Technical Note

Project No: ITM9036
Project Title: Lily Street Farm
Title: Response to DCC Comments on the Convenience Store
Ref: ITM9036-016 TN
Date: 14 September 2021

Proposed Convenience Store, Land at Lily Street Farm, Derby Road, Swanwick

DRAWN:	CHECKED:	APPROVED:
JB	JO	VE
PROJECT No:	SCALE @ A3:	DATE:
ITM9036	1:500	11.03.21
DRAWING No:		REV:
ITM9036-GA-028		C

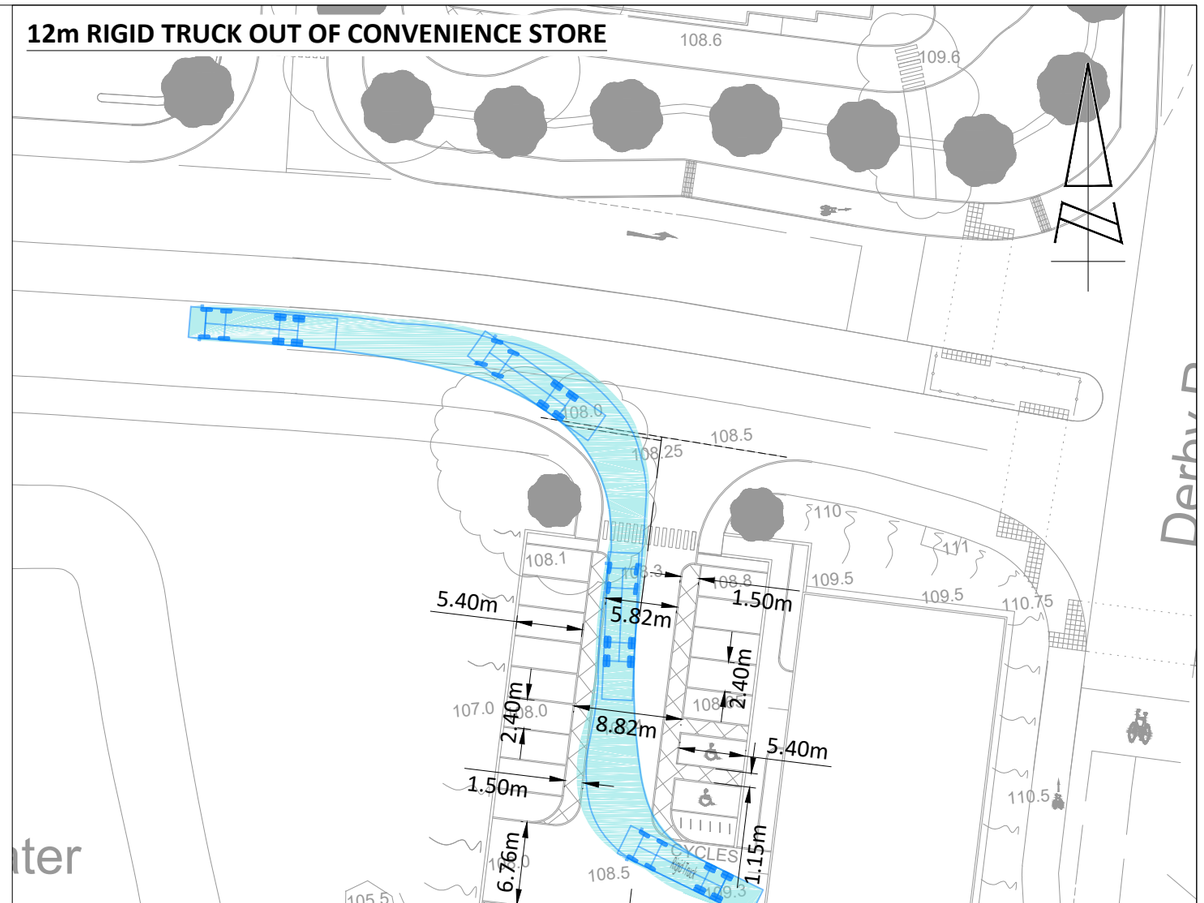
2.2 DCC have raised the query that convenience stores can be accessed via larger vehicles and that the car park layout is reliant on accurate parking of the cars and accurate positioning on the entry/exit of the car park.

2.7 DCC outline that manoeuvring within the site such as vehicles entering and leaving parking spaces could cause vehicles to back onto the spine road and potentially impact on the northern signal access to the site. The car park has been designed in line with DCC parking layout standards and in terms of the aisle width, the layout exceeds the required provision by providing a width of 8.8m including the hatched areas, which will aid car manoeuvring into and out of spaces. Drawing ITM9036-GA-028 Rev C presents the updated junction radii, swept path analysis and also includes the car park dimensions. Therefore, it is concluded that manoeuvring within the car park would not significantly impact on other vehicles entering the site.

with the signalised junction, and the swept paths within the car park for delivery vehicles accommodate a 12m rigid truck. I am aware that some suppliers use larger vehicles, and the layout shown is reliant on accurate parking of the cars, and accurate positioning on entry/exit. There would appear to be additional space for the applicant to improve the car park and servicing access arrangements.

2.3 In terms of larger vehicles servicing the site Stone Planning Services have confirmed to Amber Valley Borough Council and Derbyshire County Council that the maximum vehicle size to be used to service the convenience store will be a 12m rigid vehicle.

2.4 Drawing ITM9036-GA-028 Rev A demonstrated that a 12m rigid vehicle does not cross any parking spaces and there is space between the car parking bays and the swept path of the 12m rigid vehicle. In addition, as set out below some car park dimensions exceed the parking standards.

2.5 The swept path shown in Drawing ITM9036-GA-028 Rev A illustrated that a service vehicle could enter the site whist a vehicle was waiting to exit the site, to ensure that the service vehicle does not have to stop on the spine road if a vehicle is waiting to exit the site and this is improved by the increased exit radii, as detailed below. Drawing ITM9036-GA-028 Rev C (enclosed at the end of this note) shows the swept path analysis with the increased junction radii. Further to this, as the access only allows for left turning movements from the site, vehicles will be naturally located at the western side of the access.
